LIBERTY PARK 3RD

RE: SUB 2004-41 -- One-Step Final Plat of Liberty Park Third Addition

CASE NUMBER: SUB 2004-41 -- LIBERTY PARK THIRD ADDITION

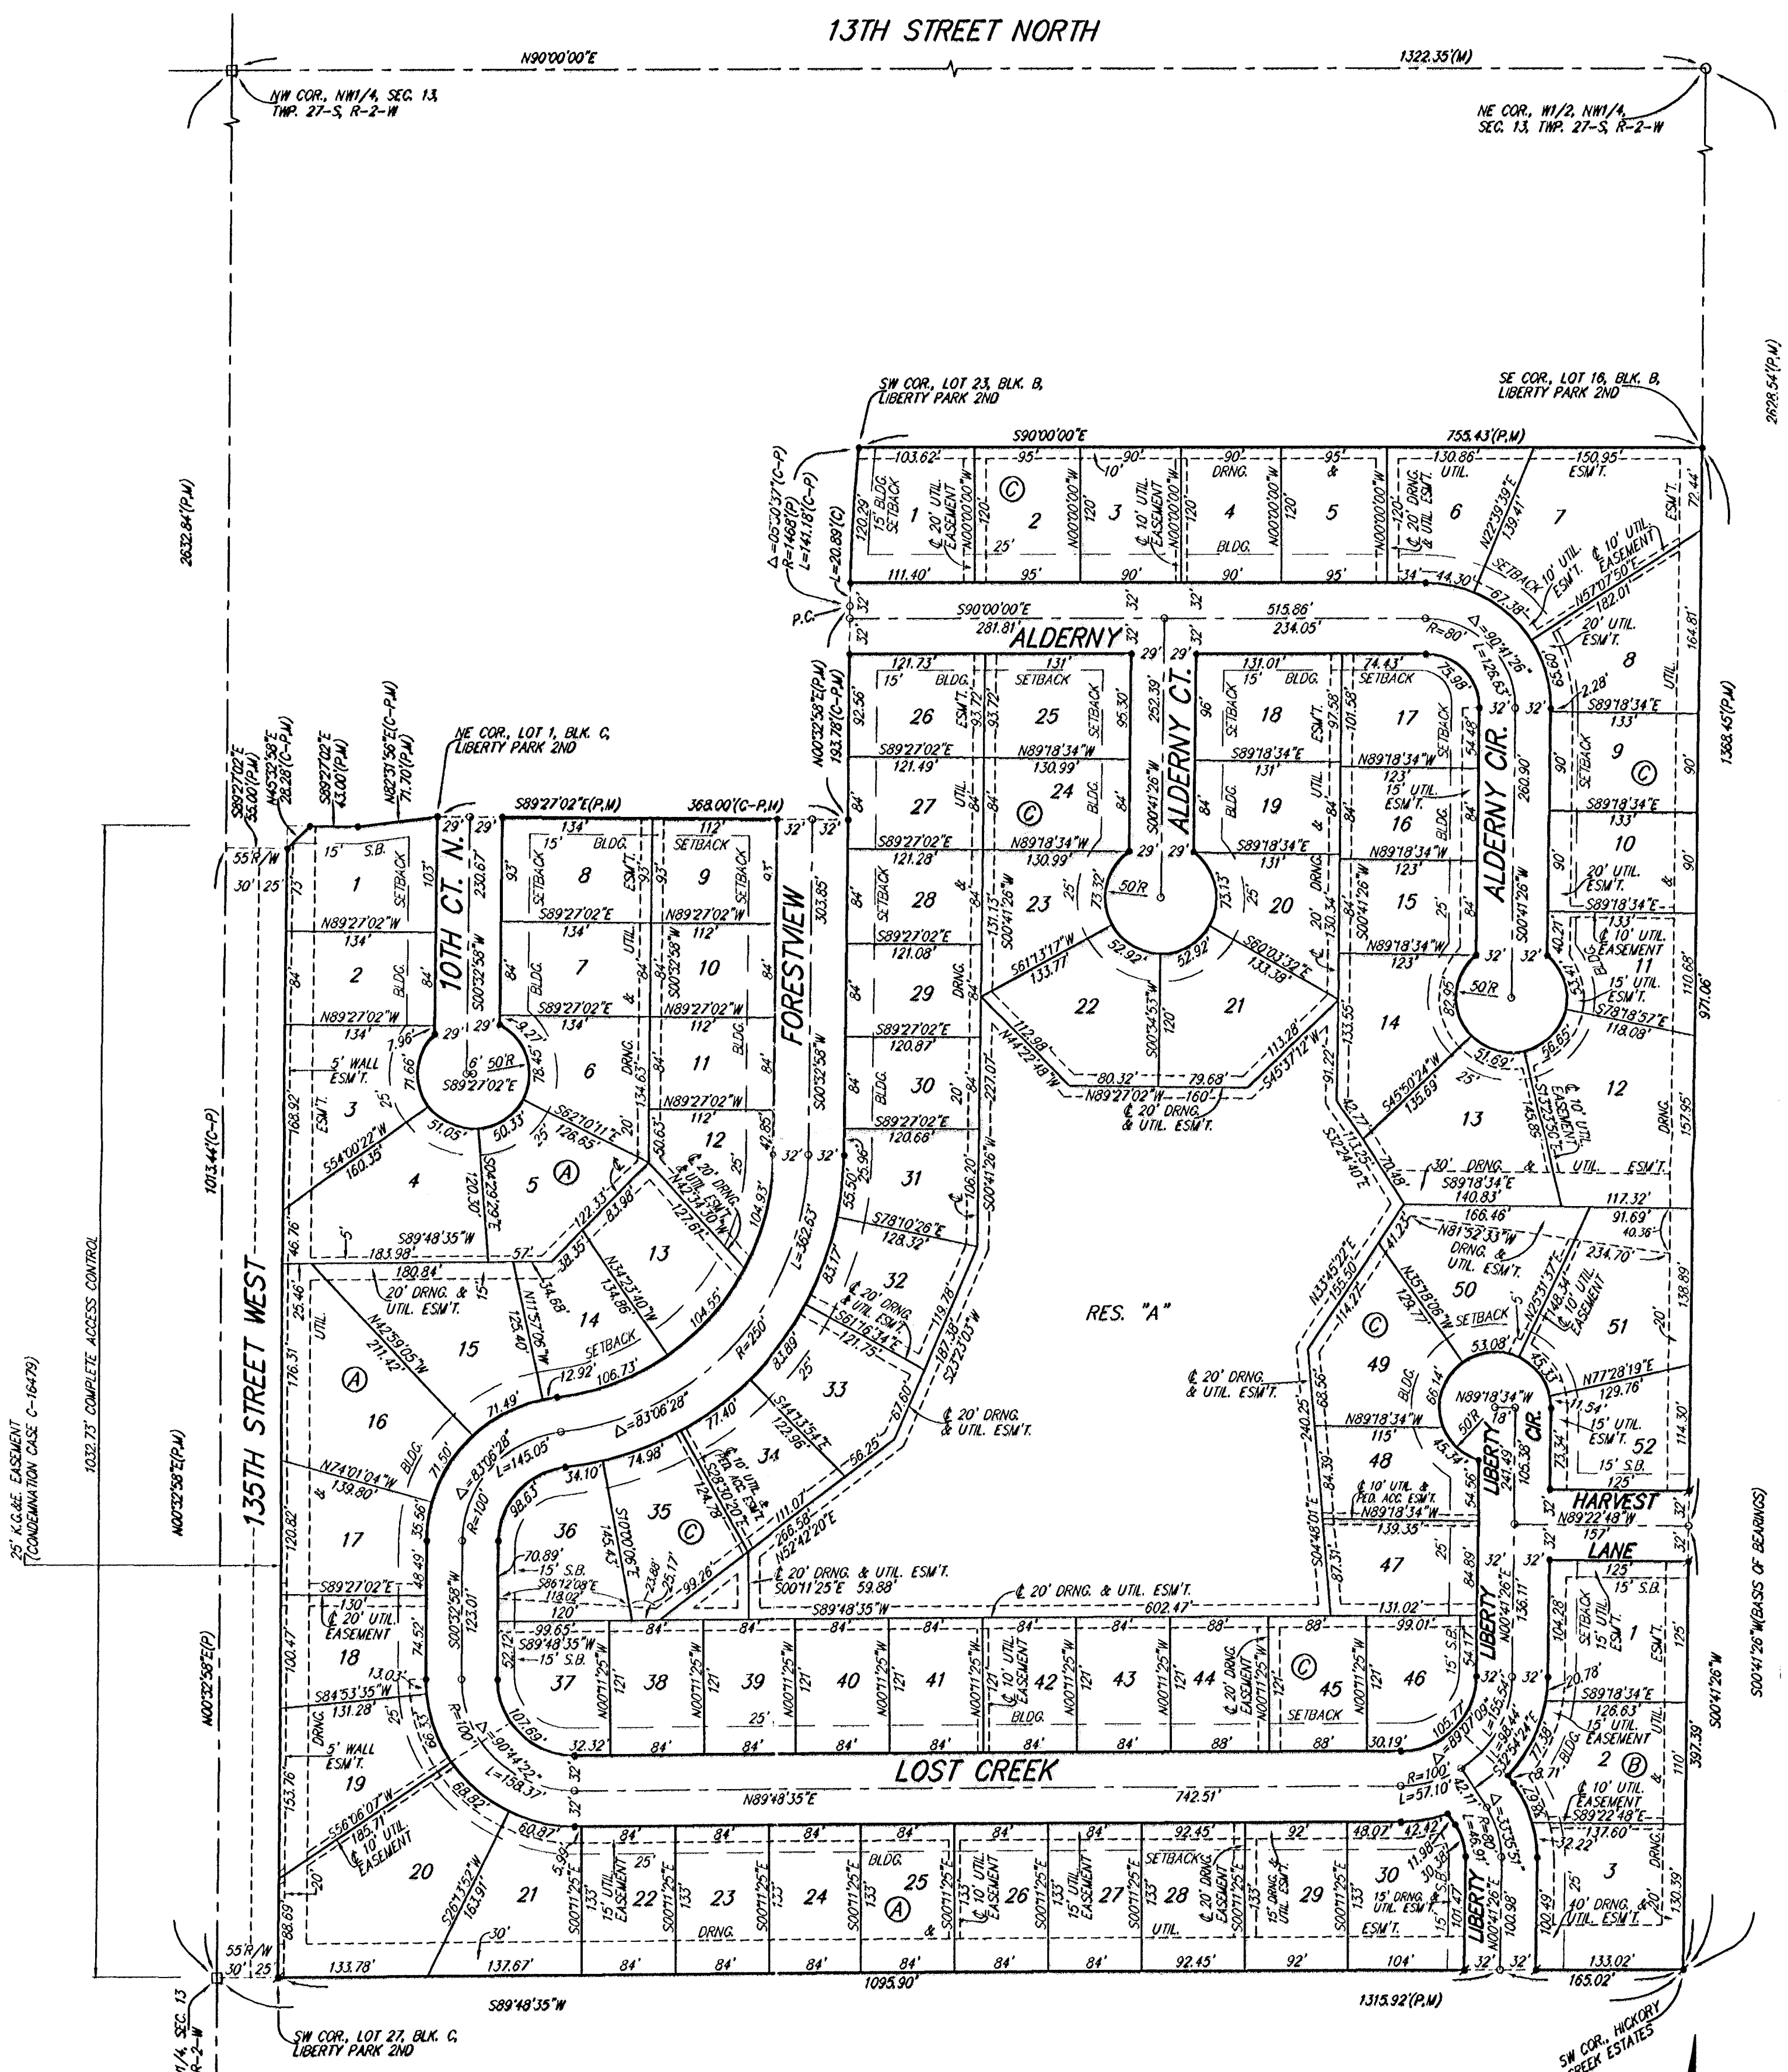
- A. The applicant shall guarantee the extension of sanitary sewer and City water to serve the lots being platted. *The applicant shall contact Debt Management regarding the submission of a respread agreement for special assessments of existing improvements.*

- C. *City Engineering* needs to comment on the status of the applicant's drainage plan. *The drainage plan is approved.*
- D. The Applicant shall guarantee the paving of the proposed streets. The guarantee shall also provide for sidewalks on at least one side of all through, non cul-de-sac streets.

- E. *Traffic Engineering* has requested a petition for future left turn lanes along 135th St. West.
- F. Provisions shall be made for ownership and maintenance of the proposed reserves. The applicant shall either form a lot owners' association prior to recording the plat or shall submit a covenant stating when the association will be formed, when the reserves will be deeded to the association and who is to own and maintain the reserves prior to the association taking over those responsibilities.

- I. The applicant shall submit a covenant which provides for four (4) off-street parking spaces per dwelling unit on each lot which abuts a 58-foot street. The covenant shall inventory the affected lots by lot and block number and shall state that the covenant runs with the land and is binding on future owners and assigns.

- J. GIS needs to comment on the plat's street names. *Liberty Ct should be revised to Liberty Cir. The easternmost Alderny Ct should be renamed Alderny Cir.*

- L. The plat's text shall include language that a drainage plan has been developed for the plat and that all drainage easements, rights-of-way, or reserves shall remain at established grades or as modified with the approval of the applicable City or County Engineer, and unobstructed to allow for the conveyance of stormwater.

- T. The representatives from the utility companies should be prepared to comment on the need for any additional utility easements to be platted on this property. **Westar Energy has requested additional easements.**
